RESOLUTION

R199 – 2024

Certificate of Appropriateness for work in the Historic Districts:

Historical Architectural Review Board
COA Preliminary Review Sheet

Roof Plan (Applicant)

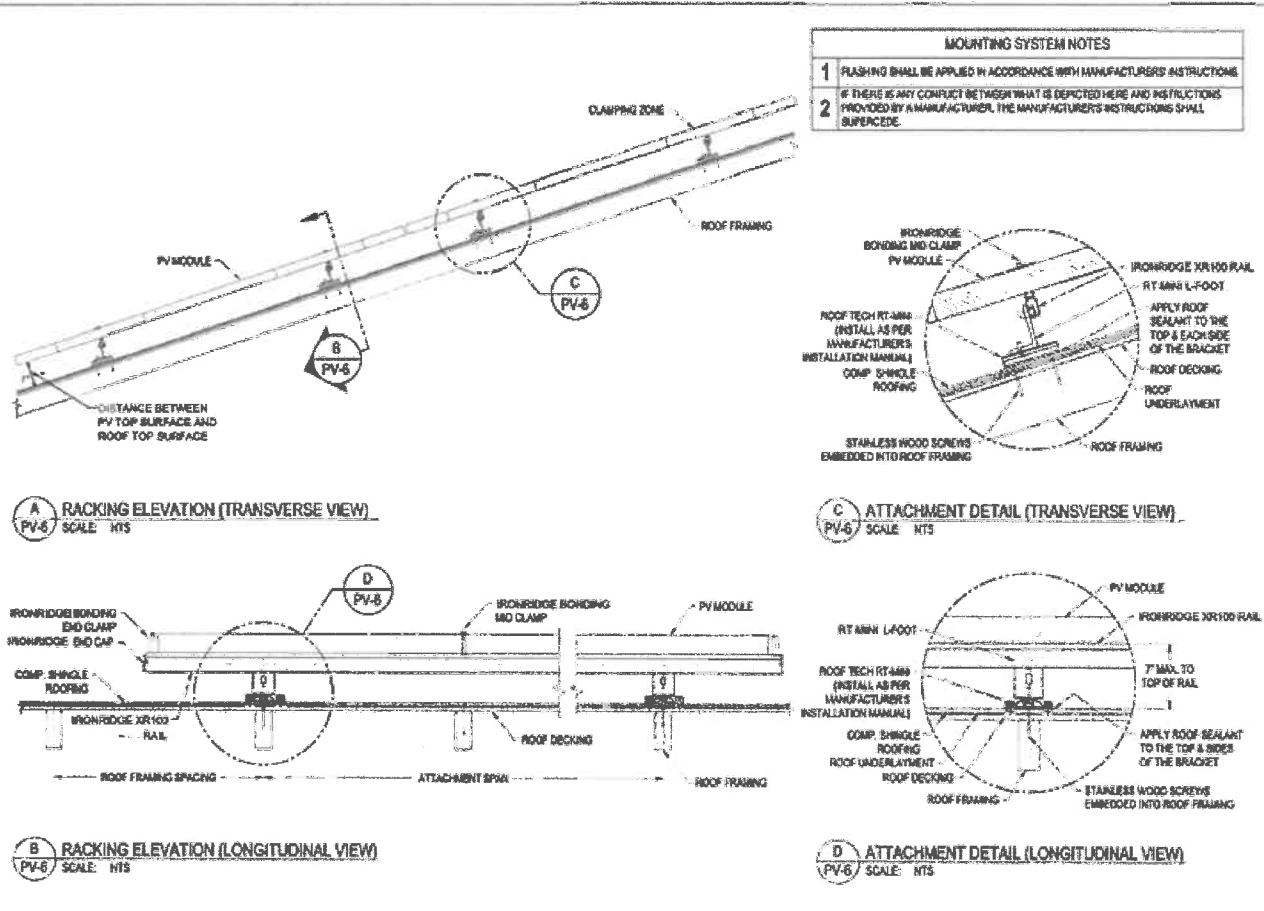
While solar panel installation is typically a staff-level review, staff recommended this application is reviewed by the HARB, given the extent of roof coverage. The application indicates that the 24 solar panels would be installed over the front and rear roof slopes, with nearly full roof surface coverage. Guidelines Section 3.10.3 states to minimize visibility of solar panels, locating collectors on rear roof slopes whenever possible, and/or as far back from the street as possible, and to avoid locating panels on roofs facing the street or the main façade. In reviewing view angles from the public right-of-way, the existing roof surface is not visible. This visibility may change when the panels are installed. The proposed installation calls for mounting the panels parallel to the roof surface, which is appropriate per the Guidelines, and that there is a maximum 7" from the existing roof surface to the top rail of the panel installation.

- In the submitted drawings, the "top rail" does not appear to align with the top of the solar panel itself. What is the expected total height of the system from the surface of the existing roof?
- Was there consideration for installing panels on the rear slope of the roof only?

Discussion: The applicant noted they submitted revised plans for the project that address some of the staff recommendations related to the visibility of the panels from the front of the structure. They reduced the number of panels from 24 to 15. The applicant noted 6" is the distance between the roof and panels (7" is the maximum distance permitted.) They are also proposing to move the electrical equipment indoors to the basement, instead of at the northeast corner of the property on the exterior. The applicant would like to know if solar panels are acceptable on the front slope of the building; the applicant thinks visibility will be minimal, due to the footprint of the building. The power disconnect will be located on the exterior of the building per NEC rules and the conduit will run up the side of the house. Mr. Huber noted that the preference would be to run this on the back of the house, which is not visible from the right-of-way. The applicant noted that they will also replace the roof to provide a solid foundation for the panels. Mr. Jordan asked what the existing roof material is; it was noted that slate is the current material that will be replaced with shingles. It was noted that roof replacement was not part of the application, so a separate application for the roof replacement will be needed.

Mr. Jordan moved to approve, with conditions, the application presented on November 4, 2024 for the installation of solar panels at 728 Liberty Street with the following conditions agreed to by the applicant following the Guidelines for Historic Districts: Chapter 3, Section 10 – Solar Energy and Energy Improvements and find no circumstances unique to the property:

- Conduit placed on the back of the house, not the along side.

- Alternate configuration utilizing only the rear surface of the roof, as presented, be installed.

Proposed Plan (Applicant)

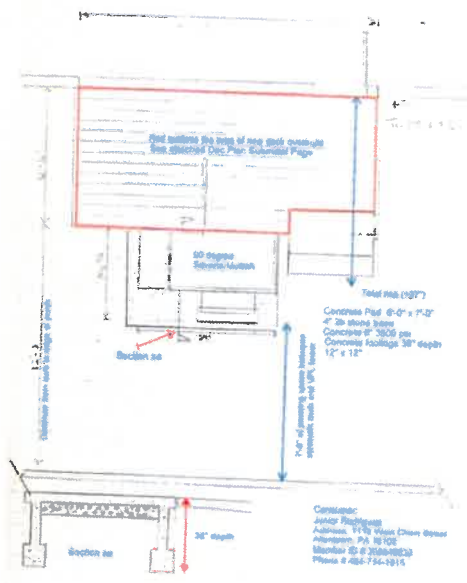
Providing an accessible entry at the primary entrance to the building is appropriate and recommended. The existing railing is called to be removed to accommodate the lift installation, and the applicant noted that the railing will be salvaged and reused. 1"x 4" pressure treated decking with dimensional framing below is proposed to raise the existing porch height to be in line with the doorway and lift. Guidelines Section 3.7.8 says "composite wood decking is an appropriate alternate to tongue and groove wood floors... Use of dimensional lumber for visible parts of a porch is not appropriate."

The proposed 1"x4" pressure treated decking would not be appropriate per the Guidelines. Salvaging and reinstalling the existing porch decking would be most appropriate. Alternatively, composite decking to match the original profile and dimension as closely as possible would be appropriate.

Reinstalling the existing railing is appropriate and maintains the historic character of the primary façade and porch. Reinstalling the railing to maintain the existing dimension from top of porch to top of railing would be appropriate.

Actions: Mr. Jordan made a motion to approve, with conditions, the application presented on November 4, 2024 for the front porch modifications to accommodate an accessible lift at 1118 Chew Street, with the following conditions agreed to by the applicant, following sections of the Guidelines for Historic Districts: Chapter 3, Section 3.7 Porches and 3.14 Accessibility and Code Required Work, and find no circumstances unique to the property:

- A composite decking to match the original in dimension be installed without affecting the surrounding railings.
- The existing configuration and materials of railings outside the liftgate entrance be preserved.
- Any code-required handrail height adjustment be addressed through the installation of a simple, reversible handrail extension mounted to on the porch-side of the existing railing and be submitted for staff review and approval based on Guidelines Chapter 3, Section 3.7-Porches and Steps.
- The composite decking material sample submitted for review and approved by staff based on Guidelines for Historic Districts Chapter 3, Section 3.7-Porches and Steps.
